SUITE 311
ORIGINAL LAYOUT
INVENTORY SUITE

*** SUITE 311 * (INVENTORY SUITE)**
NEW PLAN
-REMOVED DEN
-REVISED KITCHEN

CLIENT: ROYAL PINE HOMES

SITE: HAMPTON PLACE

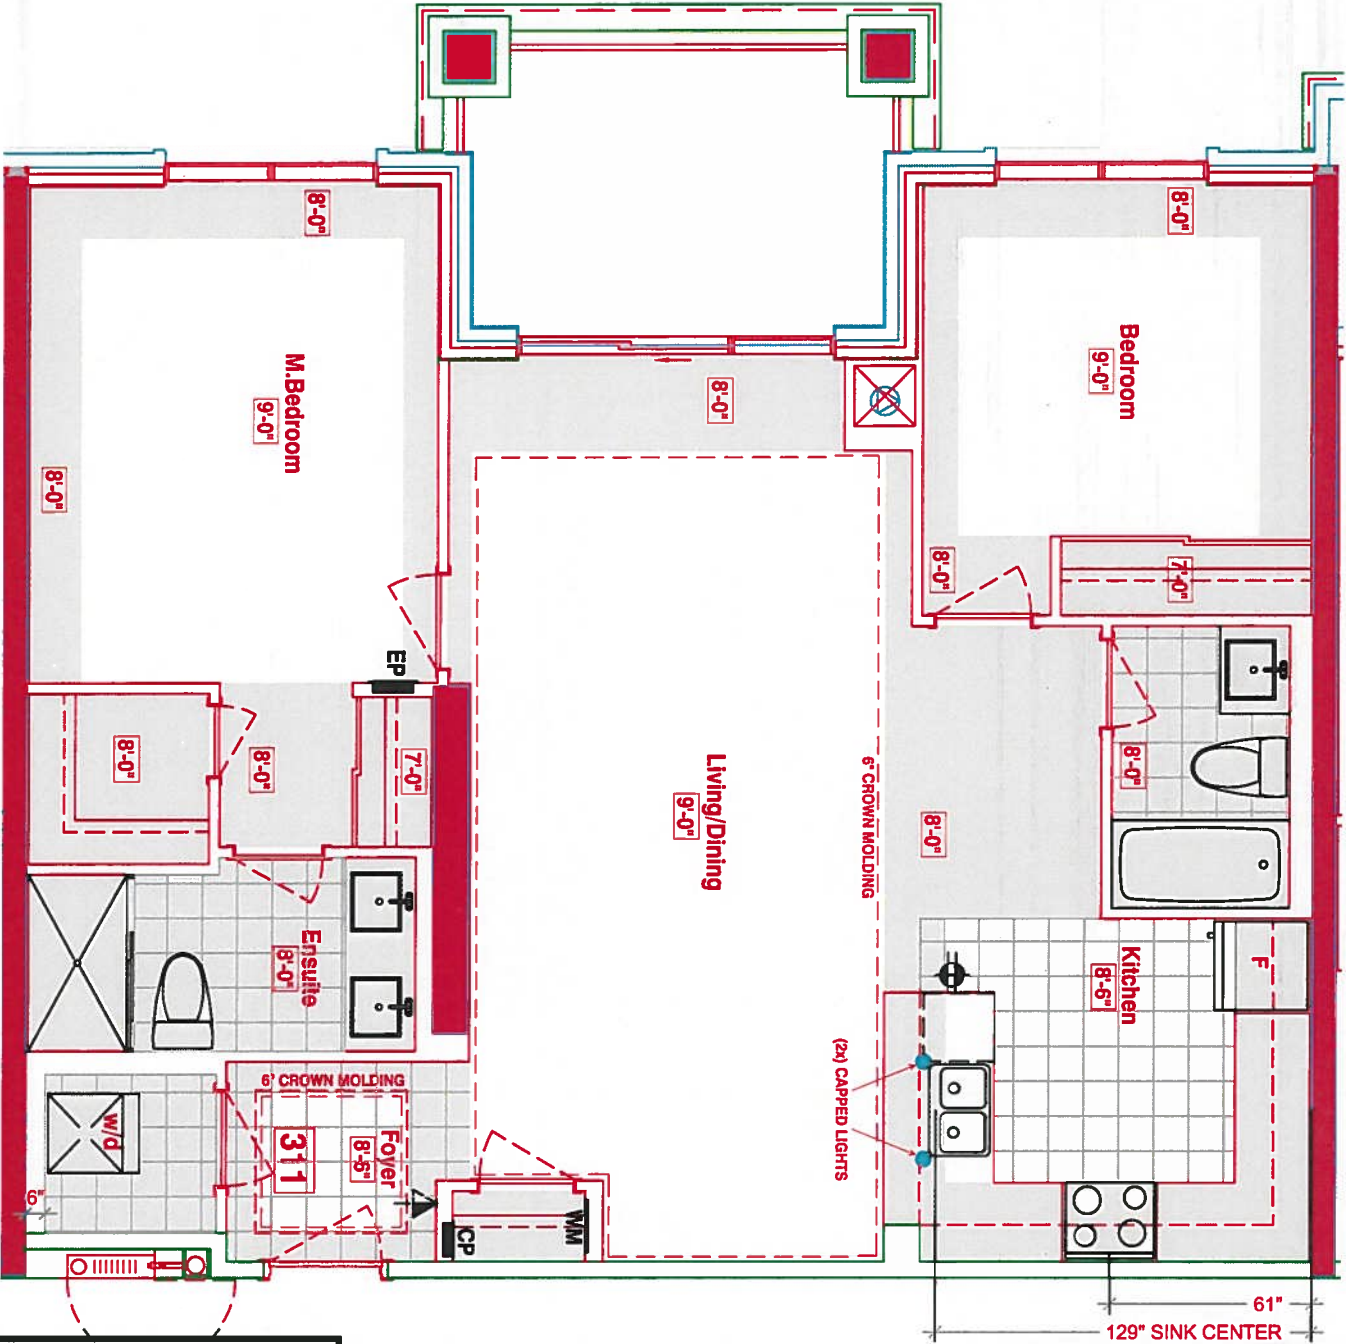
*** KITCHEN ***
CHOICE OF STD. KITCHEN LAYOUT WITH
STD. APPLIANCE PACKAGE

-(x2) CAPPED PENDANT
-(x1)
-(x) PUCK LIGHTS

*SEE ATTACHED UPG.
#1- KITCHEN LAYOUT WITH 1ST UPG.
APPLIANCE PACKAGE

*REVISED LAUNDRY DOOR SWING &
ENSUITE WALL AS PER THIS BROCHURE
